NEBRASKA MAIN STREET NETWORK

# DESIGN CASE STUDY

MOYER'S BUILDING | PITZER DIGITAL

Neligh, Nebraska

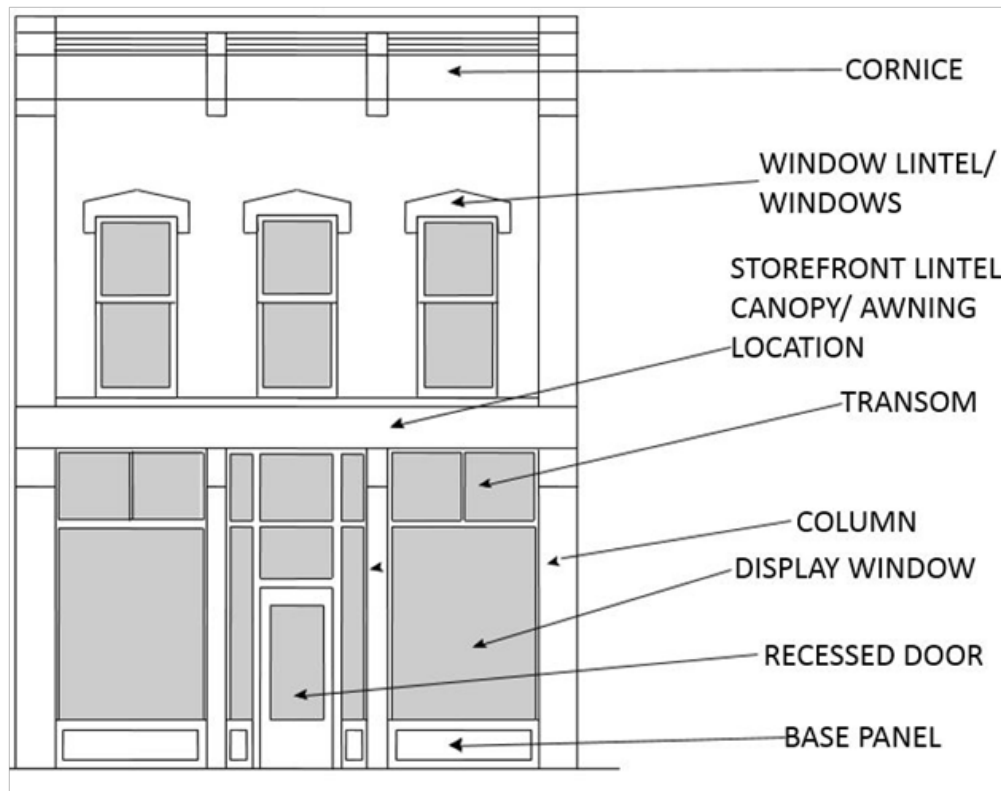
The Moyers building has a great deal of extant original fabric. The store front at street level is original and the brickwork is original and in fair to good condition. The biggest change on the façade of the building is the addition of the hipped roof canopy (*image at right: Building on the right, as it appeared c. 1970*).
